# **Geothermal Demonstration Program**

## **50 MW Power Plant**

**Baca Ranch  
Sandoval and Rio Arriba Counties  
New Mexico**

COVER SHEET  
FINAL ENVIRONMENTAL IMPACT STATEMENT  
GEOTHERMAL DEMONSTRATION PROGRAM; 50 MWe POWER PLANT  
SANDOVAL AND RIO ARRIBA COUNTIES, NEW MEXICO  
DOE/EIS-0049

Fig. 2.12. Geothermal Leases on Federal Land surrounding the Baca Location.

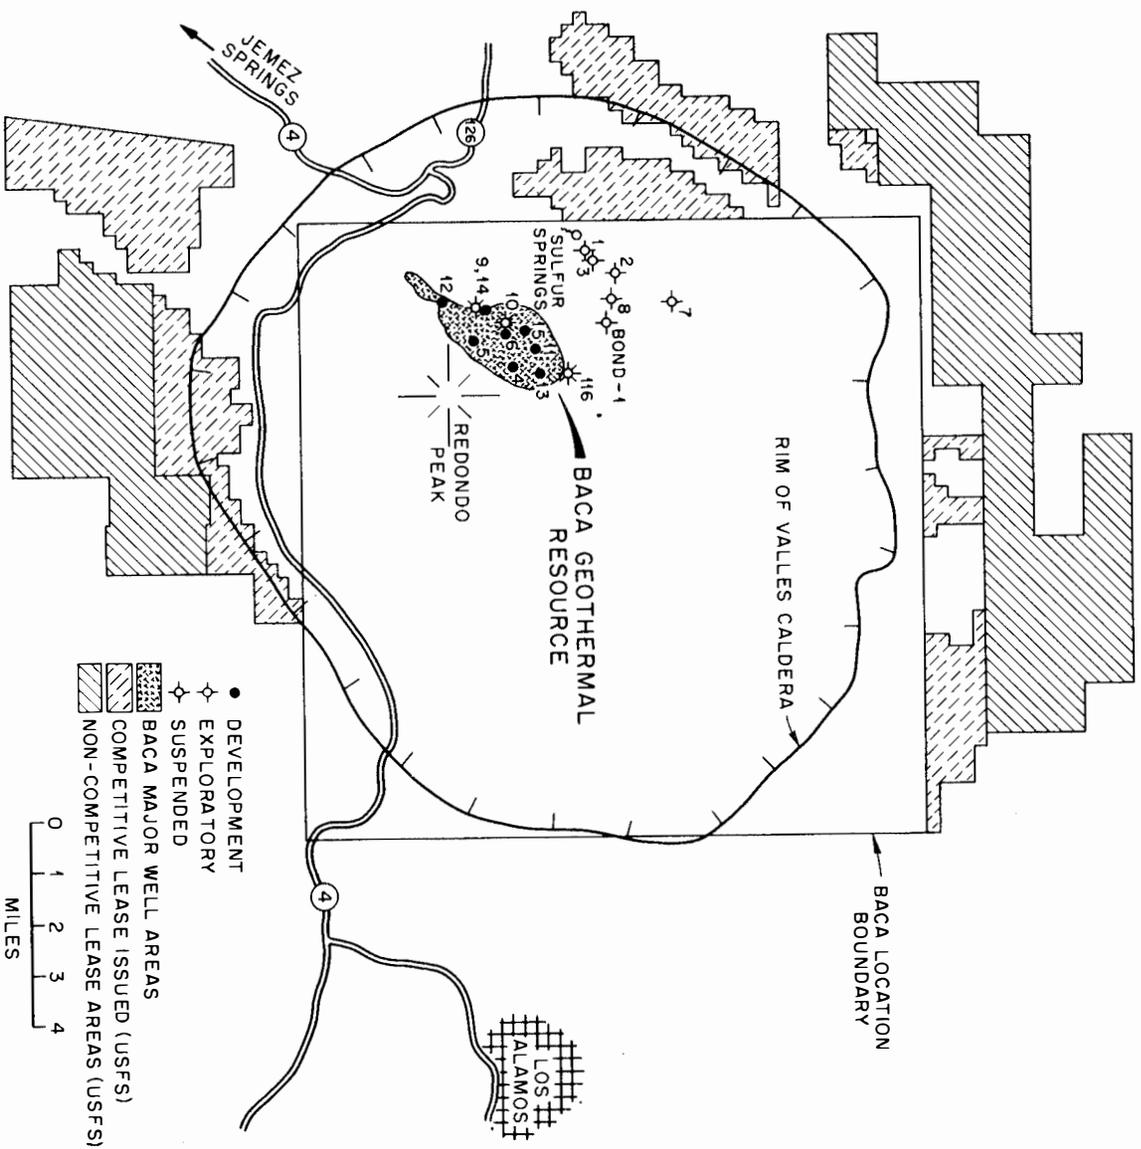
Page 2-20, figure 2.12. The symbols used for depicting exploratory and suspended wells are the same. Three wells on the map have a symbol which is not identified. This should be rechecked.

Fig. 3.10. Structure section of Redondo Creek. Source: Union Oil Company of California and Public Service Company of New Mexico, *Baca Geothermal Demonstration Plant Project Proposal*, 1978.

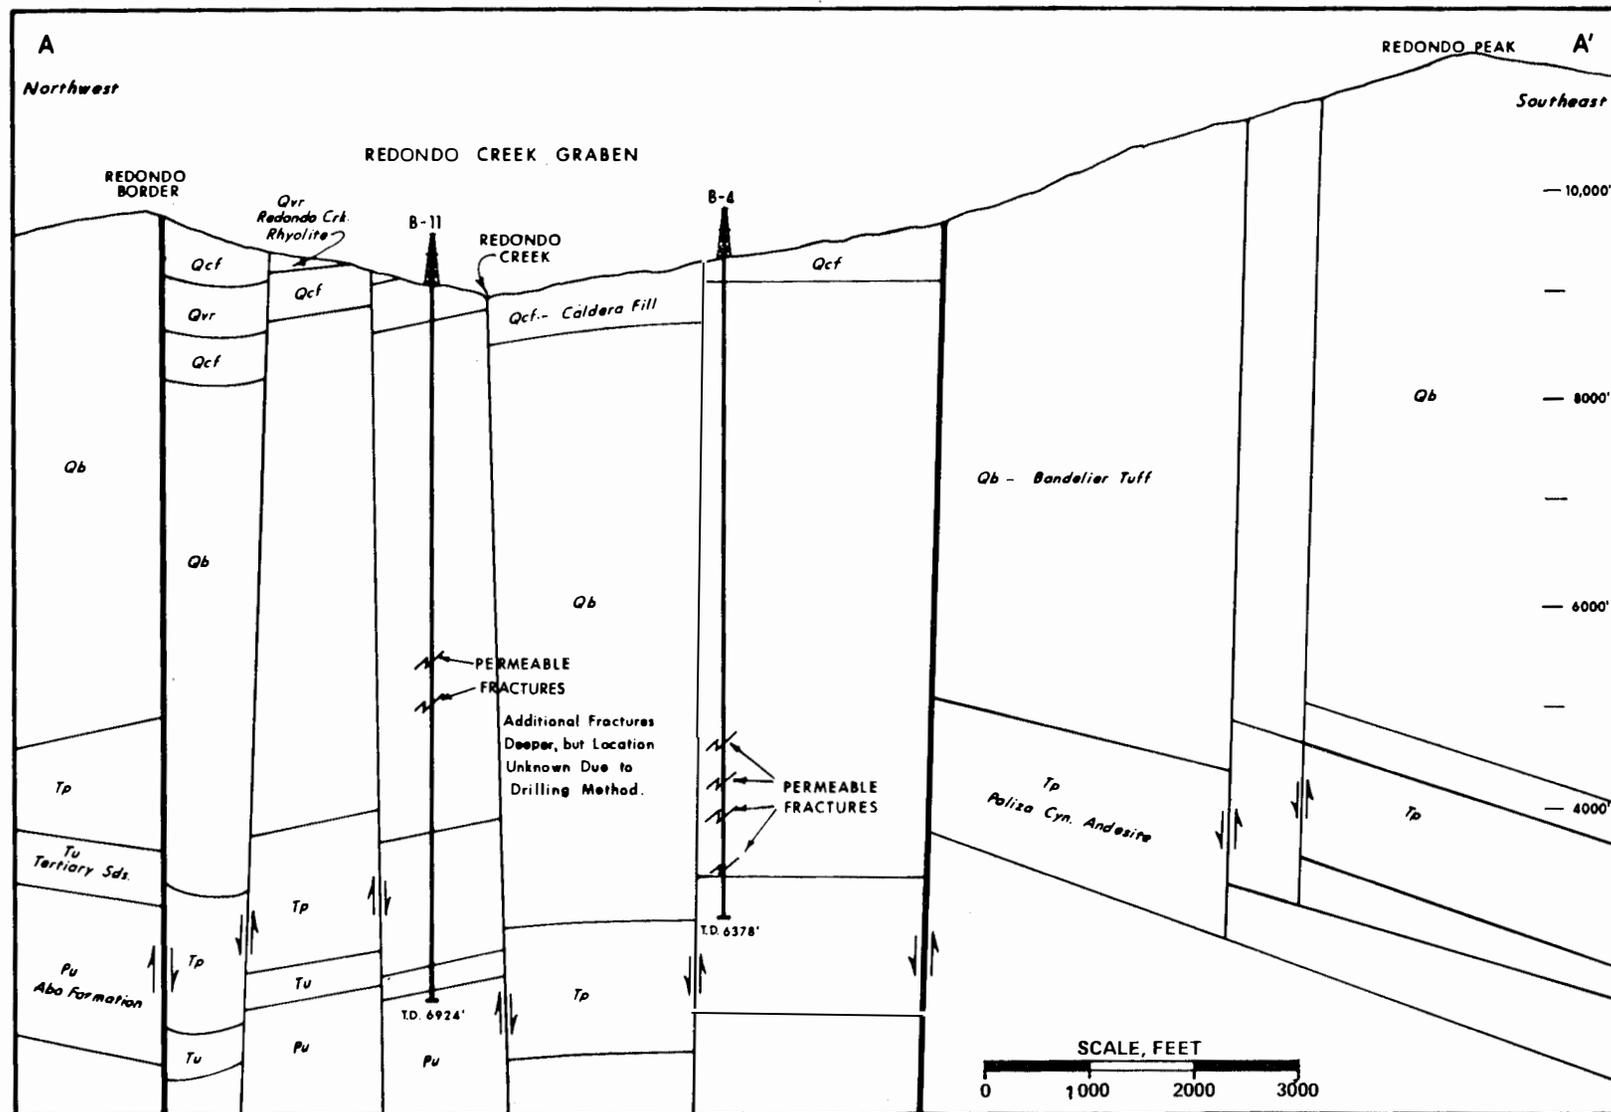
scattered, rather widely separated fractures, as suggested by figure 3.10 (p. 3-25), or is the geothermal reservoir apparently in a highly shattered zone? Has any evidence of solutioning been found thus far? Information of this type would improve the statement and aid in impact assessment.
